Work Order ID 71821

Item Name: Crosstube Turning Detail

DART AEROSPACE LTD	Work Order: 71821
Description: Crosstube Assembly	Part Number: D407-667-245
Inspection Dwg: D407-667-245 Rev: F	Page 1 of 1

DRAWING NO. D407-667-245	TITLE CROSSTUBE ASSY (407 HIGH AFT)	REV. F	DART AEROSPACE LTD ENGINEERING ORDER		D.E.O. NO. D407-667-245-F-1	SHEET NO. SHEET 1 OF 2	SCALE NTS
DRAWN <i>1</i>	CHECKED <i>9</i>	MFG. APPR. <i>E</i>	APPROVED <i>14</i>	DE APPR. <i>H</i>			
DATE 11.04.08	DATE 11.04.12	DATE 11.04.12	DATE 11.04.12	DATE 11-04-12

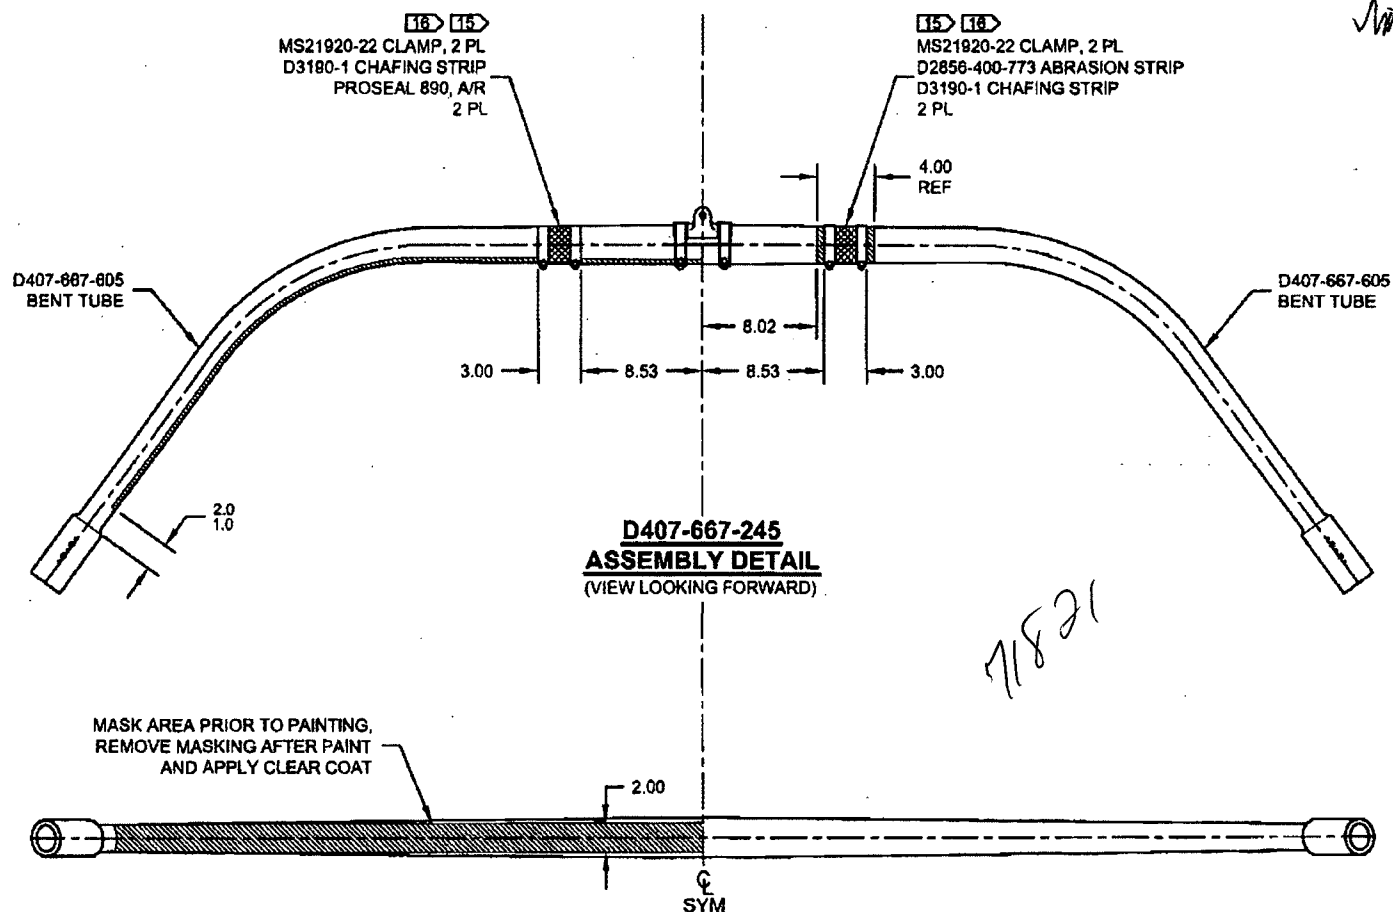
PURPOSE:

REMOVED ABRASION STRIP IN FAVOR OF A THIN LAYER OF PROSEAL 890.

NOTES 2 AND 15, SHEET 1 ARE AMENDED AS FOLLOWS:

- 2) FINISH: CHEMICAL CONVERSION COAT PER DART QSI 005 4.1
PRIME INSIDE AND OUTSIDE PER DART QSI 005 4.2
MASK UNDERSIDE OF CROSSTUBE AS SHOWN (HATCHED AREA) AND
PAINT OUTSIDE PER DART QSI 005 4.2
REMOVE MASKING AND APPLY CLEAR COAT
- 15) APPLY A THIN COAT OF PROSEAL 890 ON INSIDE CONCAVE SURFACE OF D3190-1
CHAFING SHIELDS AND LET CURE PER MANUFACTURER'S INSTRUCTIONS. INSTALL
PROSEAL D3190-1 CHAFING SHIELDS ONTO CROSSTUBE BY APPLYING A THIN COAT
OF PROSEAL 890 ONTO CROSSTUBE. BE SURE TO ELIMINATE ANY AIR GAPS.

- 2) FINISH: CHEMICAL CONVERSION COAT PER DART QSI 005 4.1
PRIME INSIDE AND OUTSIDE PER DART QSI 005 4.2
PAINT OUTSIDE PER DART QSI 005 4.2
- 15) INSTALL D2856-400-773 ABRASION STRIP WITH A 0.13 REF GAP ON BOTTOM SIDE OF
CROSSTUBE PER QSI 035.
